MAULE AEROSPACE TECHNOLOGY, INC.

**SERVICE BULLETIN NO. 17**

**SUBJECT:** Fuselage Tubes located near Forward Rudder Control Cables.

## Detail B

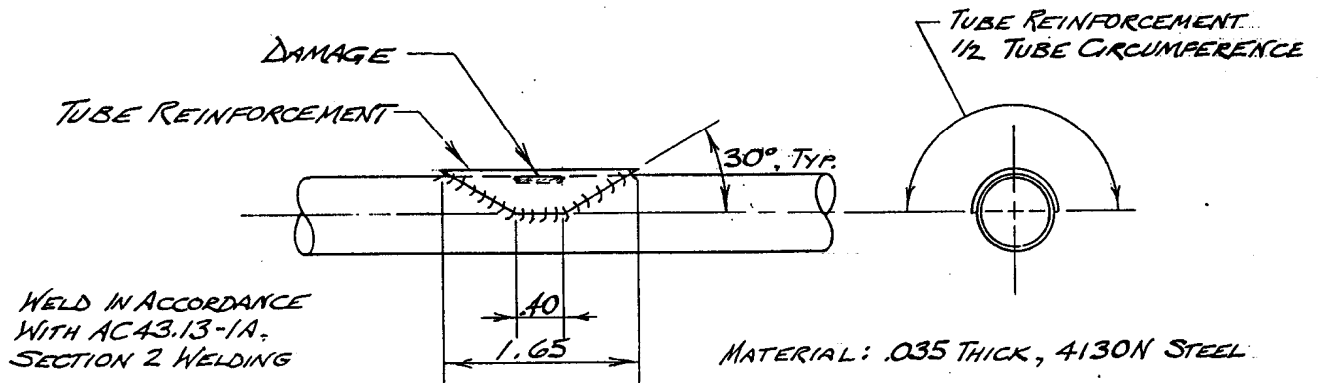
If there is any evidence of the cable having been against the structural tube, install the 3267B-4 Plastic Guide Tube per Detail B, page 2 of this Bulletin.

## Detail A

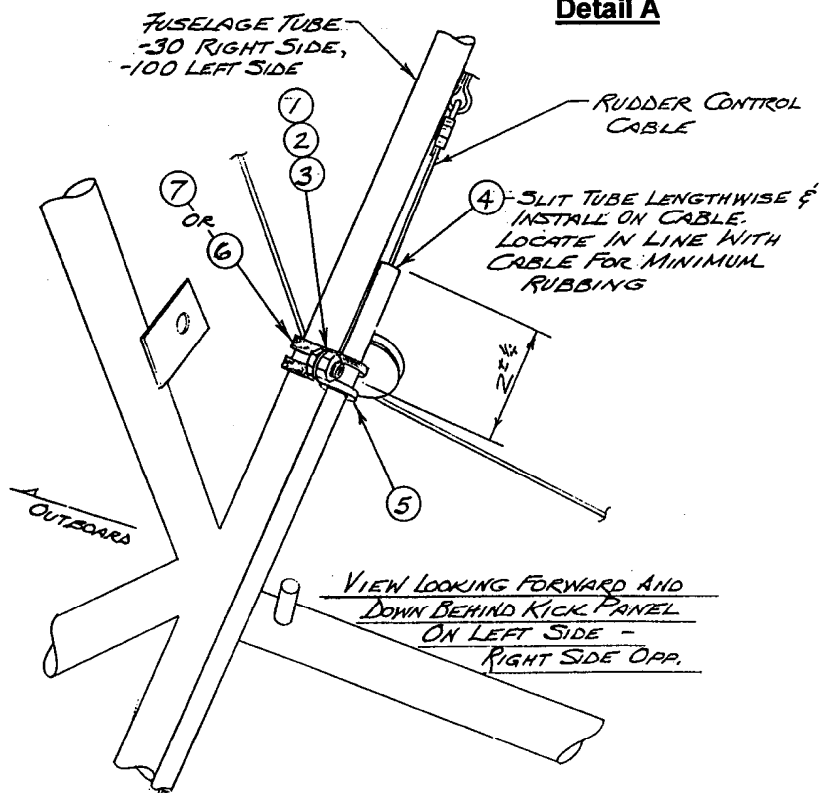
1. Remove right and left forward kick panels. Left side will require removal of fuel valve handle.
2. Inspect fuselage structural tubes directly adjacent to rudder control cables. If there is no evidence of cable rubbing, no further action is required. Complete Compliance Record Sheet and return it to Maule Records.
3. If the cable has been in contact with the structure, carefully inspect the depth and width of the damage to the associated structural tube. This damage may be blended out with a fine file if the metal removed does not exceed a depth of .010 inch and a width along the tube of ¼ inch. If either of these dimensions is exceeded, the tube must be reinforced with a welded patch per Detail A, page 2 of this Bulletin.
